District Department of Transportation

Roadway Safety Audit Edgewood Road Washington, DC

DDOT Traffic Engineering and Safety Team

September 2, 2014

Figure 4 – Illegally Parked and Standing Vehicles on Bus Pad

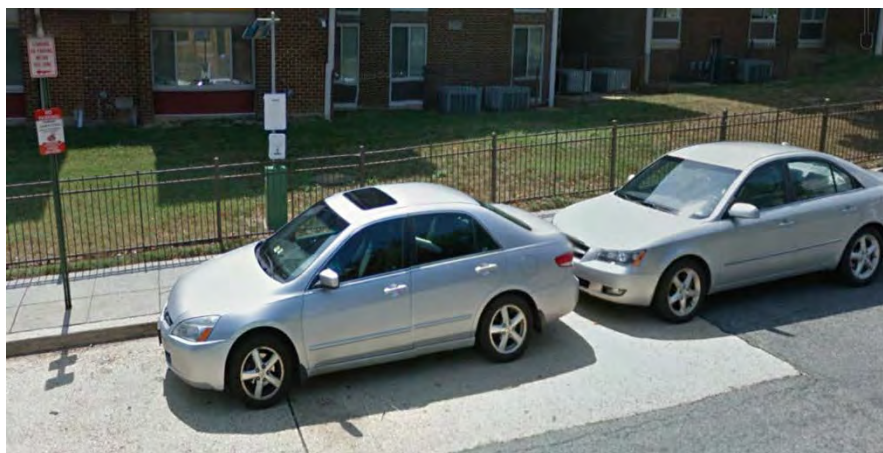
- There are parking restriction signs on Edgewood Street that prohibit parking in a bus zone. However, as shown in **Figure 4**, motorists were observed to parking and standing illegally in the bus zone. Further, the RSA team also observed parents illegally standing and parking their vehicles in the bus pad for drop-off purposes during the morning peak-hour. This creates direct conflicts between Metro bus operations and vehicles that are illegally parked and standing on the bus pad.

Figure 7 – School Bus in Wrong Lane

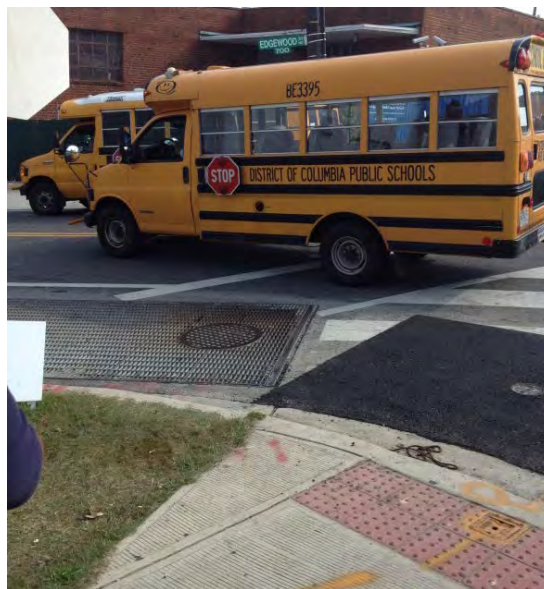
- The RSA team also observed a few motorists, especially school buses, traveling in the wrong travel lanes. This deliberate motorist behavior of driving in the wrong travel lanes, significantly increases the potential for head-on collisions, injury-related crashes and fatal crashes. **Figure 7** shows school buses traveling in the wrong travel lanes at this location.

Figure 9 – Obstruction at Pedestrian Ramp

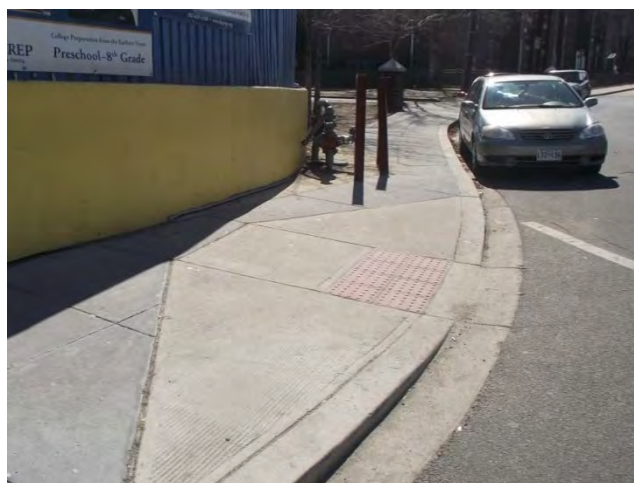
- The traffic control signs are either damaged or incorrectly mounted at this location (as shown in **Figure 8**). Further, there are no advance warning signs for the school zone installed at this location. The pavement markings for the existing crosswalk are faded and need to be replaced.
- The utility pole is installed very close to the pedestrian ramp, as shown in **Figure 9**. The utility poles obstruct access, especially for wheelchair users, to pedestrian facilities. It should also be noted that the sidewalk is very narrow at the terminus of the pedestrian ramp, and there is not enough turning space for wheelchair users to maneuver after leaving the crosswalk.

Figure 15 – Damaged Pedestrian Ramp

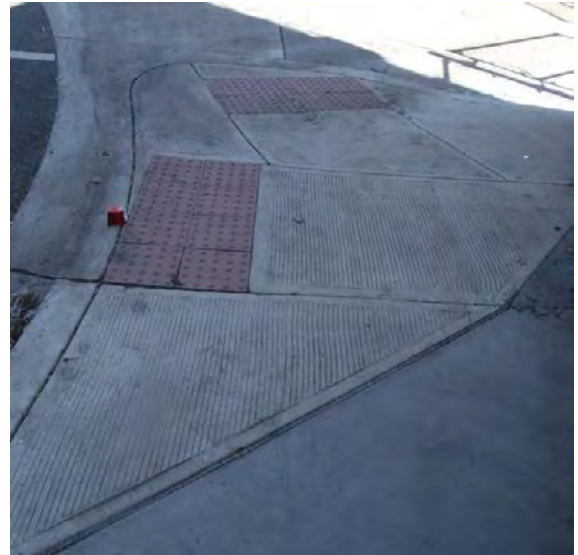
- Edgewood Street transitions to 8th Street, NE underneath the Franklin Street Overpass. There are two pedestrian crosswalks at this location. The pedestrian ramps at both crosswalks are non-standard and do not meet any ADA specifications.
- The landing areas at ramps are either missing or damaged. Further, the cross slopes are steep which create safety hazards for pedestrians, particularly wheelchair users. **Figure 14** and **Figure 15** show the non-standard and damaged ramps, respectively at this location.

Figure 17 School Valet Layout

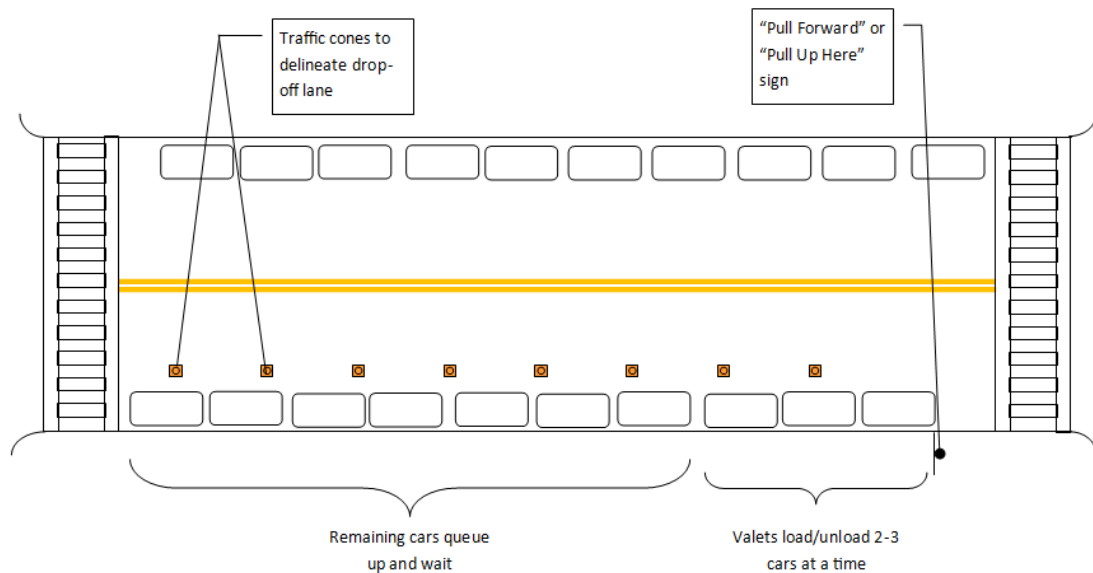
The study intersections along Edgewood Street, particularly the school access, experience significant vehicular congestion during the drop-off and pick-up sessions. Hence, the schools should implement a valet system in which school staff, parent volunteers and/or student safety patrols help students into and out of cars so that parents don't need to park their vehicles. School valet system would shorten the length of time that each individual vehicle spends at the school, and as such, would alleviate traffic congestion on Edgewood Street. Further, many schools in the District of Columbia have successfully implemented the School Valet programs. The following suggestions are recommended:

- Schools should identify specific areas for drop-off and pick-up and operate a valet system to help students into and out of the vehicles. One suggested location is Edgewood Street, between the school access and 8th Street, be designated as school valet for the drop-off and pick-up activities; for e.g. school valet area on Edgewood Street, between the school access and 8th Street, NE
